BUILDING PERMIT REPORT

Address 25 Crescent St, Peaks Island Date 27 July 94

Reason for Permit To Construct a single family dwelling (Found-  
ation already existing) Bldg. Owner: Stephen Demos

RE: 25 Crescent St., Peaks Island, ME

Site Plan  
Dwelling for  
S. & V. Demos  
Peako Island  
Crescent Street  
Oct '92 1"=20 ft.

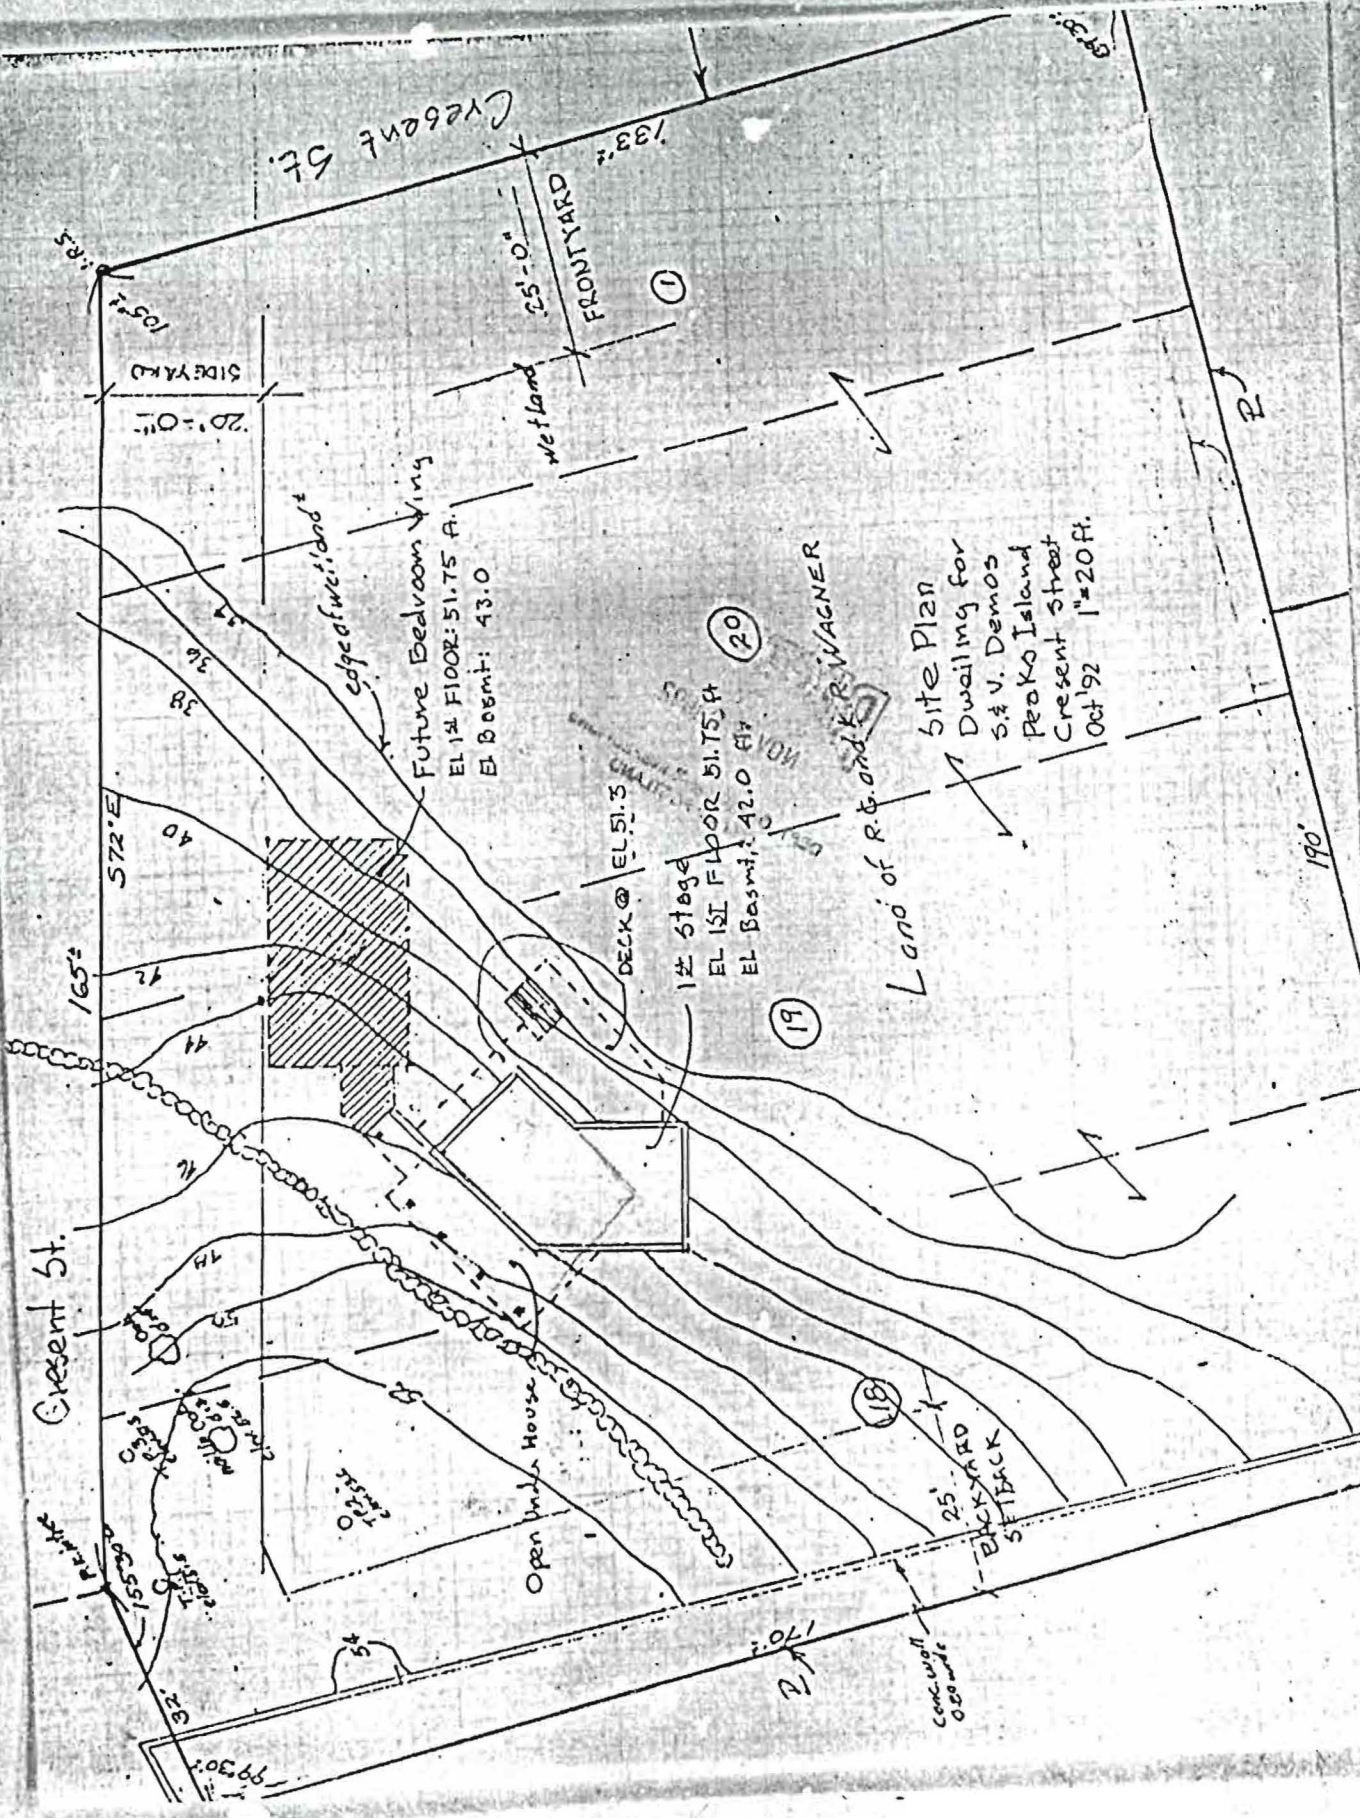
- Date -
- Zone Location - IR2
- Interior or corner lot
- Use - single fam
- Sewage Disposal - see HHE-200 by Frick dated 10-8-92
- Rear Yards - 25' opposite seashore
- Side Yards - Crescent 20' other ~~to~~ edge of wetland
- Front Yards - seashore Ave 25'
- Projections - none
- Height - unknown
- Lot Area - 29,800 sq ft
- Building Area - OK
- Area per Family - entire
- Width of Lot - OK
- Lot Frontage - OK
- Off-street Parking - 2 cars
- Loading Bays - N/A
